SERVICE LETTER NUMBER 56			
TITLE: MAIN LANDING GEAR SHOCK STRUT REPLACEMENT – 3000A, 3450A			
BY: MAB	AIRCRAFT MAKE/MODEL(S):	FLOAT MODEL(S):	NOTE(S):
APP: SDW	SEE COMPLIANCE SECTION	3000A	COMPLIANCE MANDATORY
DATE: 4/15/2019	OF THIS SERVICE LETTER	3450A	
REV: B.1			S/L P/N 1002434

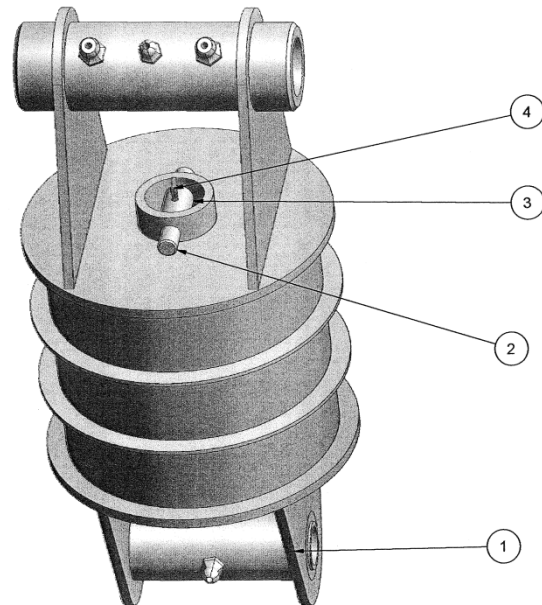
The cotter pins in the retaining pin at the top of the shock strut may have been damaged and come out. This will result in the retaining pin working its way out and the shock strut coming apart.

This may be a result of taxiing on rough taxiways, landing on rough landing strips, hard landings, or corrosion.

For 3000A or 3450A Floats – Install Service Kit #39 (p/n 1002521)

12. Assemble item (1) p/n 30A04000-120 lower end shock strut, existing rubber donuts, spacers, bushing and grease zerk.
13. Install lower end shock strut assembly in gear drag tube and bolt together.
14. Use hand pump to lower gear to the down position, line up holes in item (2) p/n 30A04476 retaining pin and item (3) p/n 30A04459-002 sleeve.
15. Reinstall tire and brake.
16. Lower aircraft to ground; apply enough weight to install item (2) p/n 30A04476-004 retaining pin and item (3) p/n 30A04459-002 sleeve.
17. Line up cotter pin holes and install item (4) p/n MS24665-151 cotter pin.
18. Install track spreader plate.
19. Install gear indicator arm in shock strut.
20. Install access cover on float.
21. With installation complete, Do Complete Gear Cycle. Raise Aircraft off ground.
See Note in Step 7.
